Access Compliance Report Public Rights-of-Way (Curb Ramps)

Main Street: ALITA_LN Cross Street: HICKORY_BRANCH_RD Location: SE

ADA ID: RPAT211109103922 Ramp Type: Type 4 - Parallel Initial Pass/Fail: Fail Overall Compliance: No Severity Score: 32

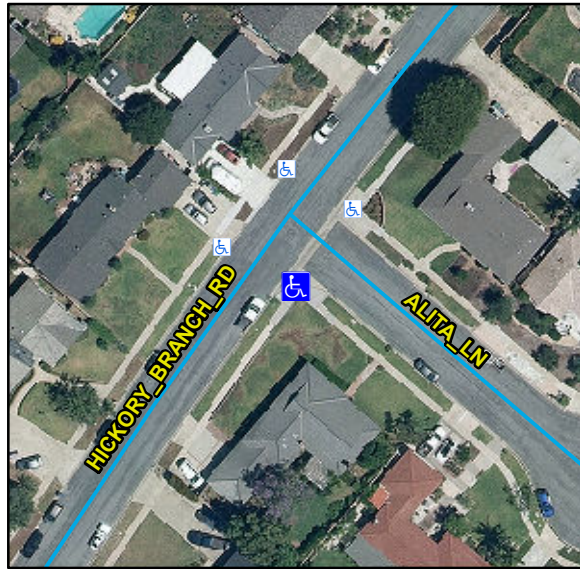
Compliance	Description	Data	Compliance	Description	Data
N/A	Ramp Length LT (in)	150	N/A	Ramp Length RT (in)	115
Yes	Ramp Width LT (in)	85	Yes	Ramp Width RT (in)	95
No	Ramp Run Slope LT (%)	13.9	Yes	Ramp Run Slope RT (%)	2
Yes	Ramp Cross Slope LT (%)	0.8	No	Ramp Cross Slope RT (%)	3.5
N/A	Landing Present	N/A	N/A	DWS Provided	N/A
N/A	Landing Length (in)	N/A	N/A	DWS Contrast	N/A
N/A	Landing Width (in)	N/A	N/A	DWS Length (in)	N/A
N/A	Landing Run Slope (%)	N/A	N/A	DWS Full Width	N/A
N/A	Landing Cross Slope (%)	N/A		DWS Offset Type	N/A
N/A	Landing Movement Obstructed?	N/A	N/A	DWS Offset Left (in)	N/A
	Landing Movement Type	N/A	N/A	DWS Offset Right (in)	N/A
N/A	Landing Shared	N/A			
N/A	Clear Space	Yes			
N/A	Clear Space To Crosswalk (in)	N/A			
N/A	Marked Crosswalk 1	No	N/A	Marked Crosswalk 2	No
	Crossing 1 Direction	NE		Crossing 2 Direction	NW
N/A	Marked Crosswalk 1 Width (in)	N/A		Marked Crosswalk 2 Width (in)	N/A

Remove & Replace Curb Ramp With Two New Directional Ramps or Equivalent.
